Access Compliance Report Public Rights-of-Way (Curb Ramps)

Intersection ID: N/AMain Street: YORK_CENTERCross Street: N/ALocation:SWADA ID: F461134B860BRamp Type: Directional2Initial Pass/Fail: FailOverall Compliance: NoSeverity Score:10

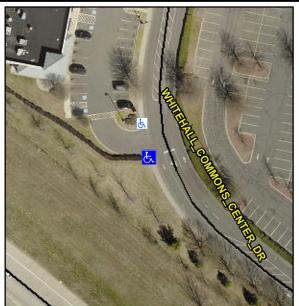
•	•	No	Ramp Width (in)	38.0	N/A	Grade Break Slope (%)	0.0	
		Yes	Ramp Slope (%)	1.4	N/A	Grade Break XSlope (%)	0.0	
		Yes	Ramp XSlope (%)	3.4				
		N/A	Flare Type LT	N/A	N/A	Flare Type RT	N/A	
		N/A	Flare Slope LT (%)	N/A	N/A	Flare Slope RT (%)	0.0	
Surveyor Notes:		N/A	Flare Traversable LT?	N/A	N/A	Flare Traversable RT?	N/A	
N/A		N/A	Landing Length (in)	0.0	N/A	DWS Provided?	N/A	
		N/A	Landing Width (in)	0.0	N/A	DWS Contrast?	N/A	
		N/A	Landing Slope (%)	0.0	N/A	DWS Length (in)	N/A	
		N/A	Landing X Slope (%)	0.0	N/A	DWS Full Width?	N/A	
PROW/ADA:		N/A	Landing Curb? (Y/N)	N/A	N/A	DWS Offset LT (in)	N/A	
R304.5.1		N/A	Shared Landing?	N/A	N/A	DWS Offset RT (in)	N/A	
		N/A	Gutter Ponding?	0.0	N/A	Gutter Slope (%)	N/A	
		N/A	Gutter Lip Ht (in)	0.0	N/A	Gutter X Slope (%)	N/A	
		N/A	Painted X Walk1?	No		Road Slope (%)	0.1	
			X Walk 1 Direction	To N		Road X Slope (%)	5.8	
			X Walk 1 Width (in)	N/A		Clear Space?	N/A

X Walk 1 Slope (%)	0.1	N/A	Clear Space to XWalk (in)	N/A	
			X Walk 1 X Slope (%)	5.8	N/A	Storm Grate/Utility Hazard?	N/A	
		N/A	Ramp inside XWalk1?	N/A		Storm Grate/Utility Type		
		N/A	Any Obstructions?	N/A			N/A	
Total Cost:	1800.00		Obstruction Type		Yes	Surface Condition? (G/P)	Good	
				N/A	N/A	Curb Slope (%)	13.0

rossible solution		riela measurements/component compnance						
Possible Solutions:		Compliance Description			Comp	ompliance Description		
Remove & Replace Entire R	lamp.	N/A	Ramp Length (in)	53.0	N/A	Grade Break?	N/A
